Questions from Chair McMahon with responses from Staff in red.

Docket Item #16 DSUP #2025-10001 2601 Cameron Street

Re: George Mason Elementary School Tree Removal summary analysis: 2601 Cameron Mills Road
IMEG# 24005288

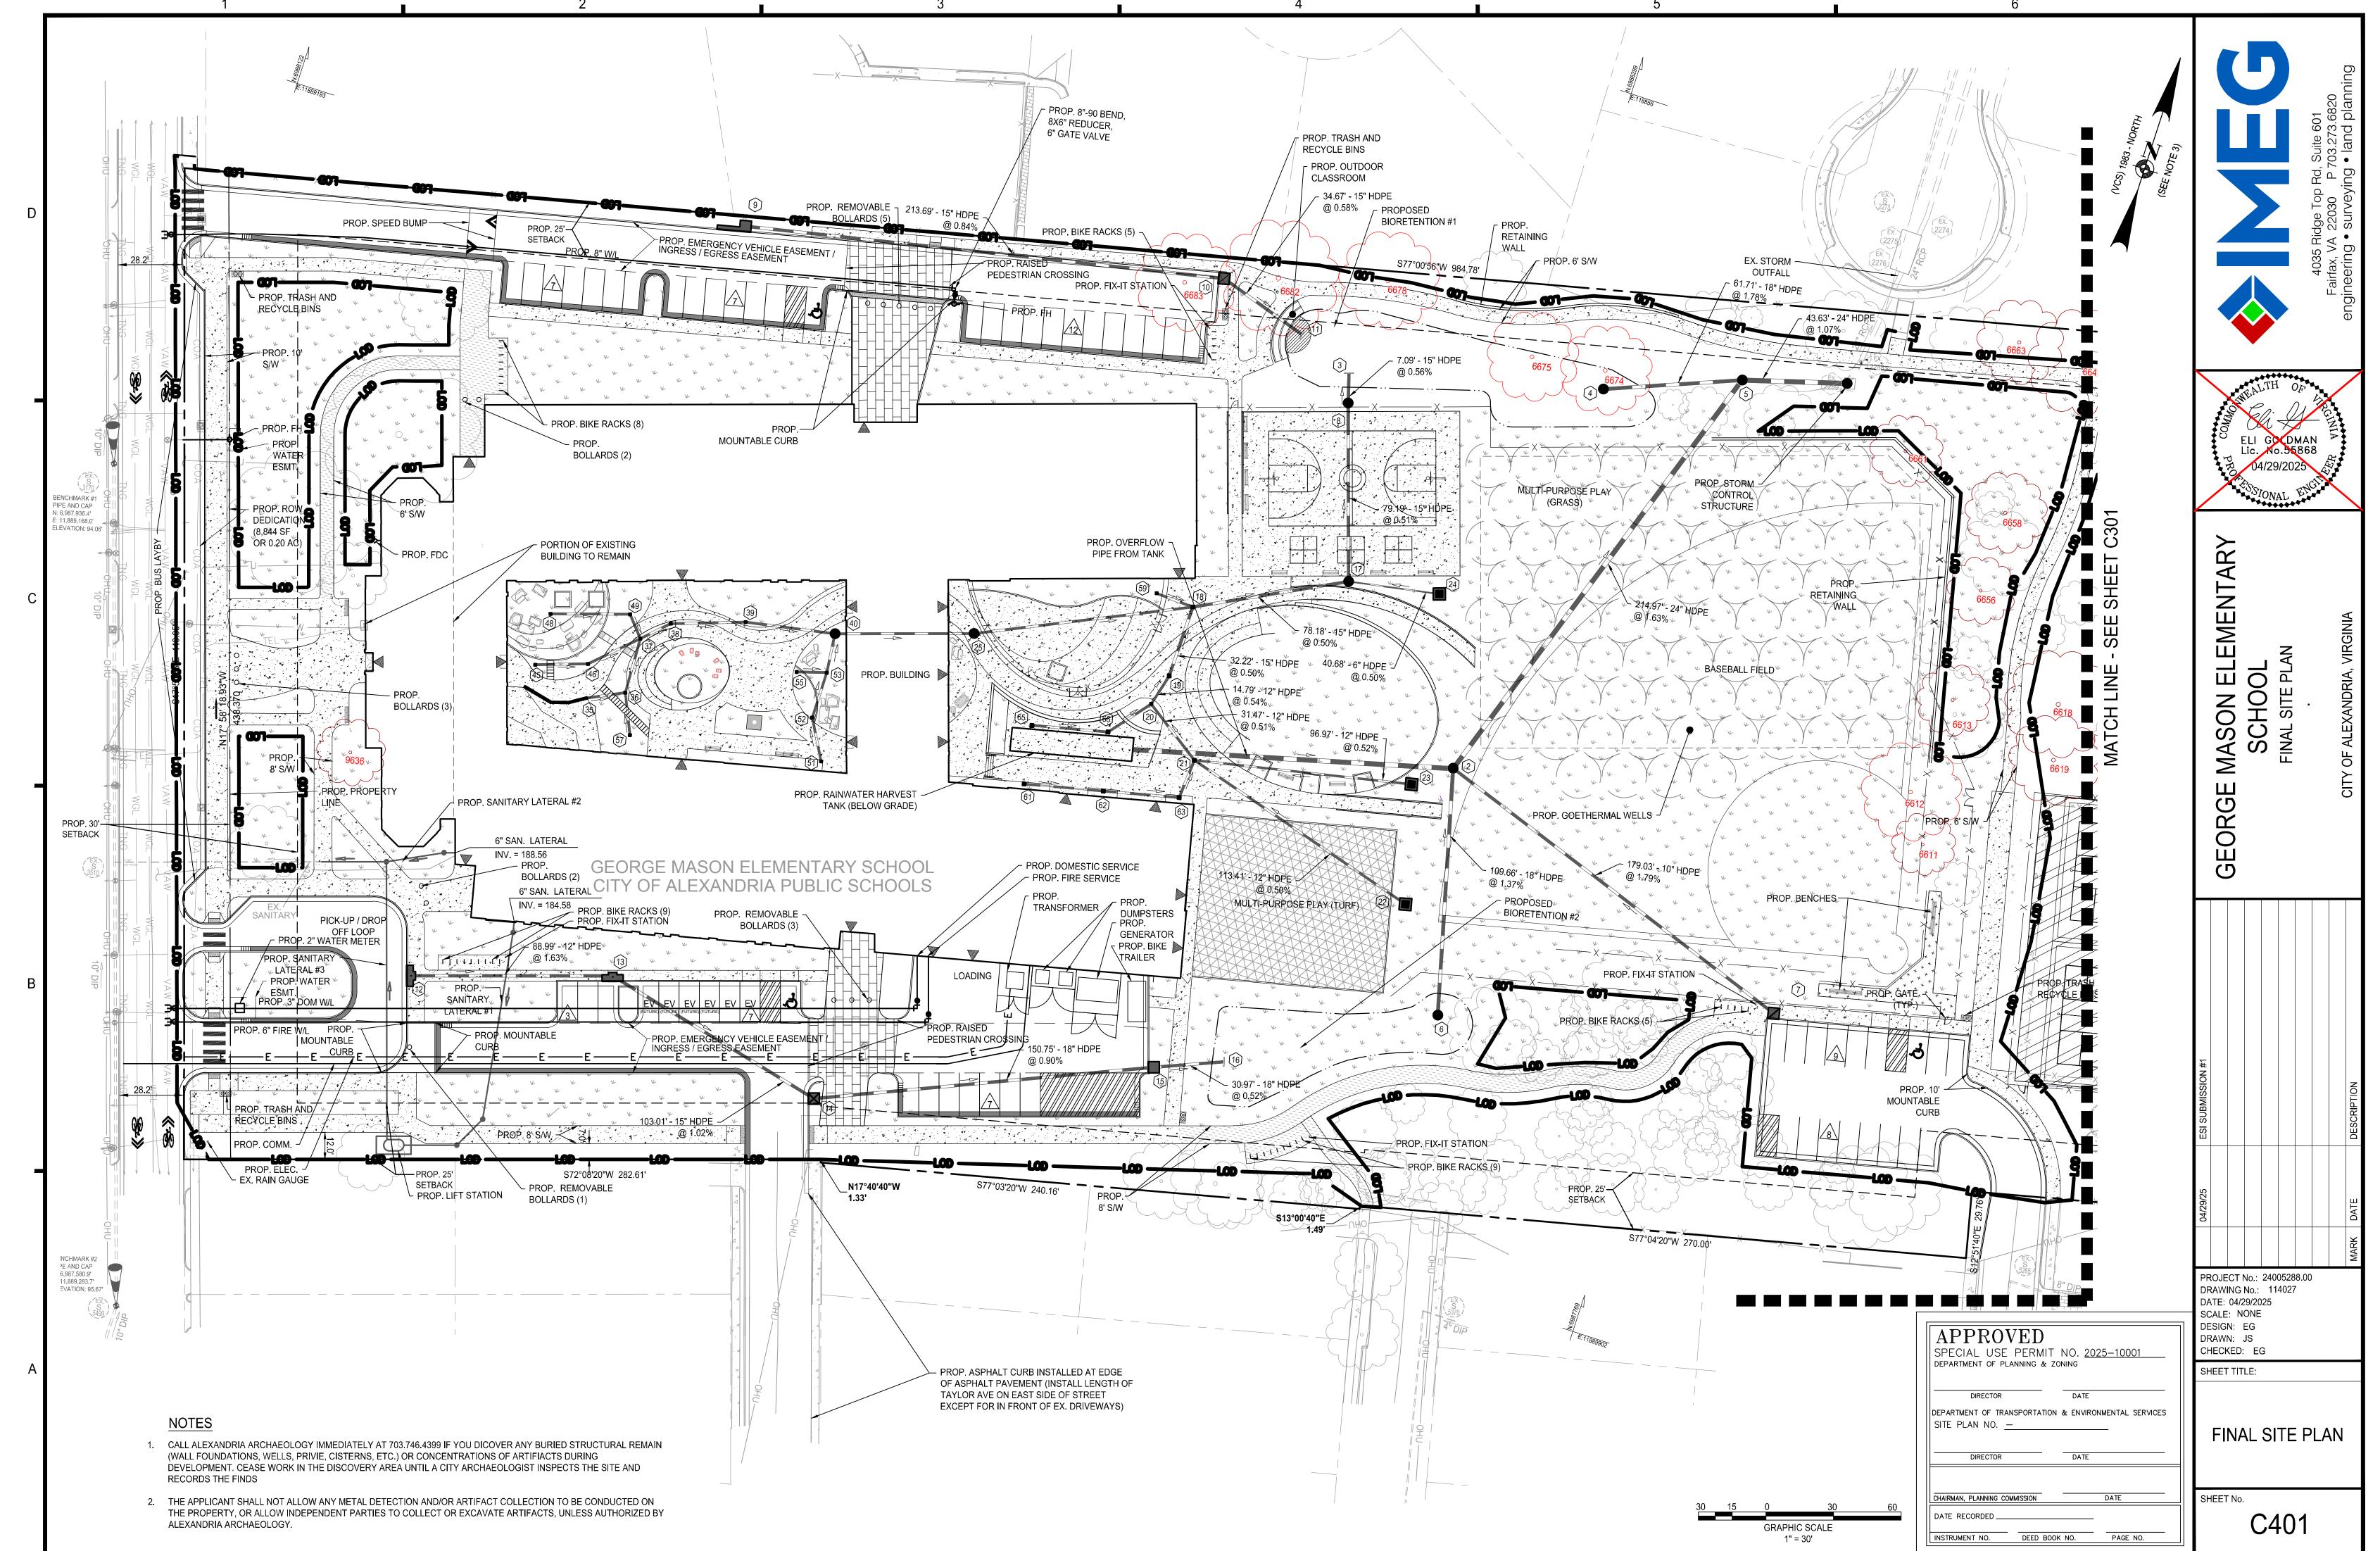
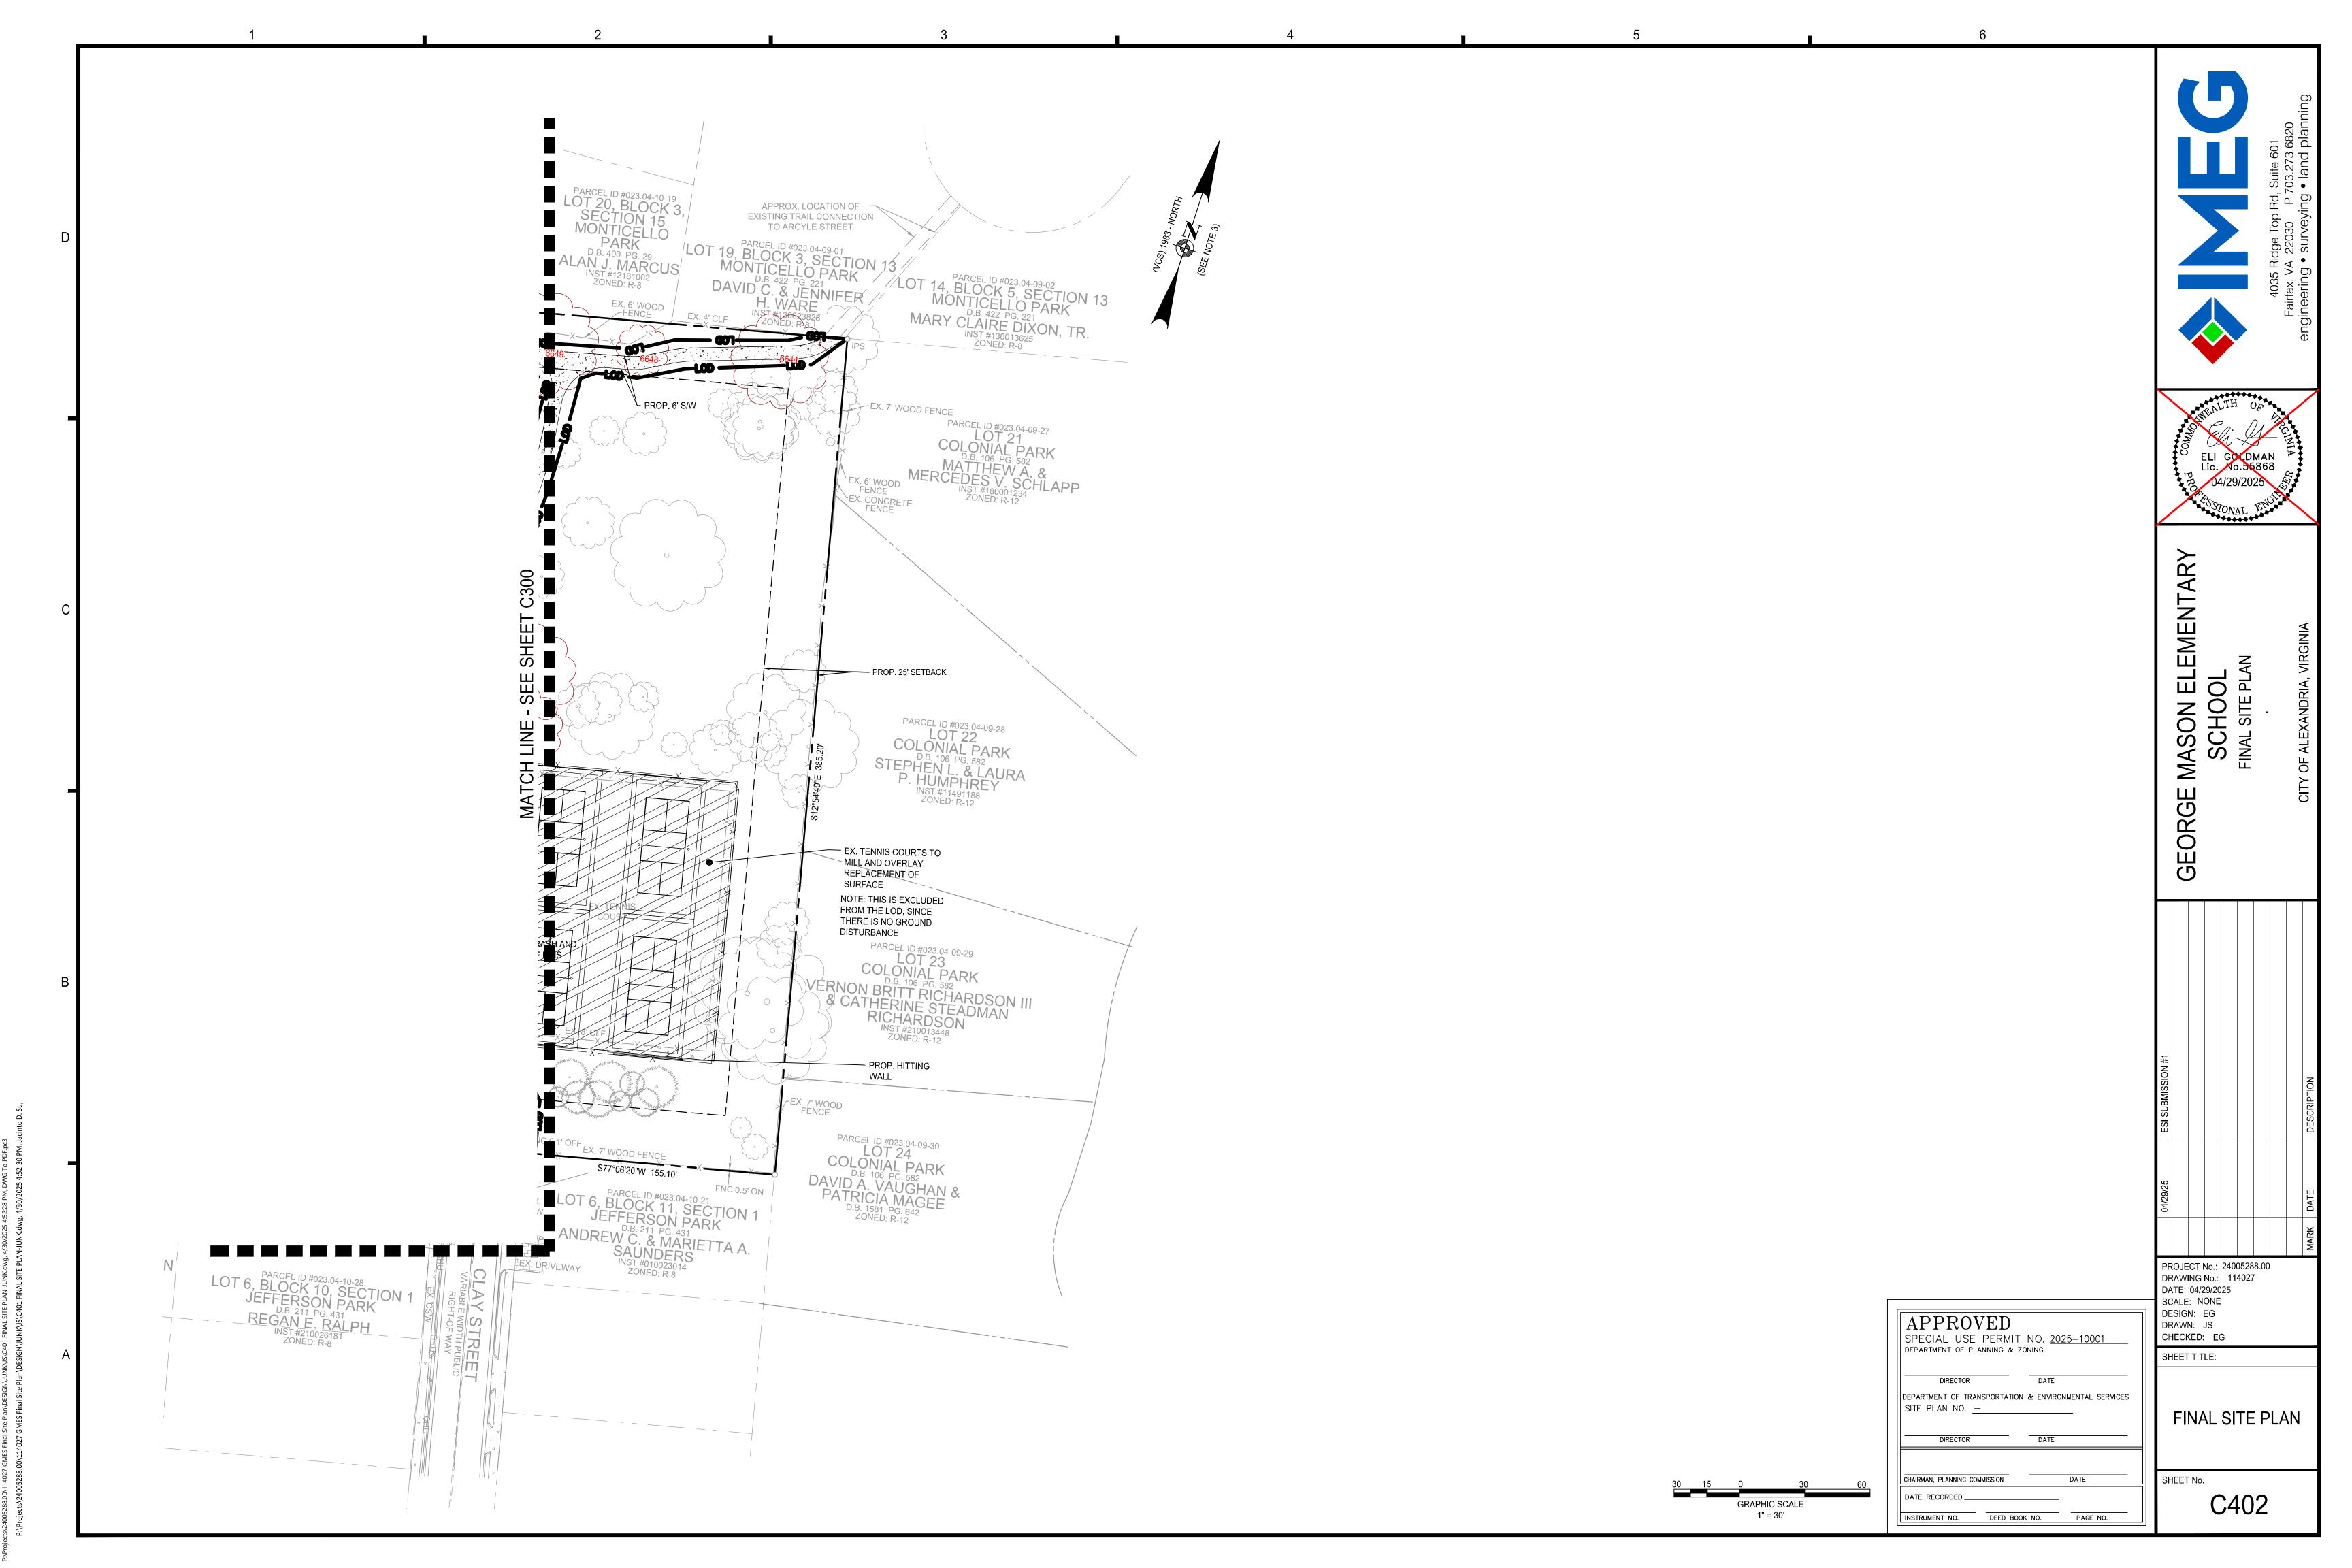
Proposed Tree Removal analysis:

- 12 of the Identified trees in question (#9636, #6683, #6682, #6678, #6674, #6661,# 6649, #6648, #6644, #6612, and #6661) as seen on the associated GMES Tree Mark up 2025-05-01, are located inside the Limits of disturbance. This means that these trees will experience 100% CRZ and SRZ disturbance due to grading, internal road improvements, increased parking, storm water management improvements, installation of geothermal wells, and park pathway improvements. The level of disturbance these trees will experience is not survivable and they will need to be removed

- Tree # 6613 is 28" White Oak (Quercus Alba). Tree 6613 is proposed to be removed due to the level
 disturbance of its root zone from proposed grading and the installation of geothermal wells on the eastern
 half of the property. These site improvements are calculated to remove 58% of the CRZ and 25% of SRZ.
 Even with tree protection measures, such as tree protection fencing or root pruning, the level of impact to
 the CRZ and SRZ is so severe that tree #6613 would not survive the development and should be removed.

- Tree # 6618 is a 45" Black Oak (Quercus Velutina). Tree #6618 is proposed to be removed due to the level of disturbance to it's CRZ and SRZ from the pathway improvements on the western side of the property. The removal of the existing pathway as well as the regrading and installation of the new pathway would remove 44% of Tree #6618's CRZ and 20% of it's SRZ. Even with protection measures, such as tree

- Tree# 6619 is a 36" Black Oak (Quercus Velutina). Tree #6619 is proposed to be removed due to the high level of disturbance to it's CRZ and SRZ from the park pathway improvement on the eastern side of the property. The removal of the existing pathway as well as the regrading and installation of the new pathway would remove 43% of tree #6619's CRZ and 27% of it's SRZ. Even with tree protection measures, such as tree protection fencing or root pruning, the level of impact to the CRZ and SRZ is so severe that tree #6619 would not survive and should be removed.

- Tree # 6656 is a 24" Black Oak (Quercus Velutina). This tree is in very poor condition with a condition rating of 53, as noted on Tree schedule of the GMES Tree and Vegetation protection plan. This rating is due to poor trunk structure from a very heavy lean towards the existing baseball field, as well as approximately half of the crown being dead, and there being a visible pocket of decay/ heart rot present in the upper trunk. Since this tree is located in a park next to a public athletic field and is currently in poor condition, I would recommend this tree to be removed regardless of development impact because it is currently a hazard. However, in addition to tree #6656's poor condition, 32% of the trees CRZ will be removed due to grading improvements and the installation of the geothermal wells to the east and park pathway improvements to the west. Due to the poor existing condition and the sever impact to the CRZ from site improvements this tree should be removed.

- Tree #6658 is a 32" White Oak (Quercus Alba). Tree #6658 is proposed to be removed due to the high level of disturbance to the CRZ due to grading improvements and the installation of the geothermal wells on east side of the tree and the park pathway improvements to the west. These improvements are proposed to remove 45% of the trees CRZ. This is well above the 30% disturbance threshold and this level of disturbance to the CRZ is so severe that tree #6658 would not survive the development and should be removed.

- Tree #6663 is 34" Pignut Hickory (Carya Glabra). Tree #6663 is proposed to be removed due to a high level of disturbance to it's CRZ and SRZ from the park pathway improvements on the western side of the property. The removal of the existing pathway as well as the regrading and installation of the new pathway would remove 42% of it's CRZ and 26% of it's SRZ. Even with tree protection measures, such as tree protection fencing or root pruning, the level of impact to the CRZ and SRZ is so severe that Tree #6618 would not survive the development and should be removed.
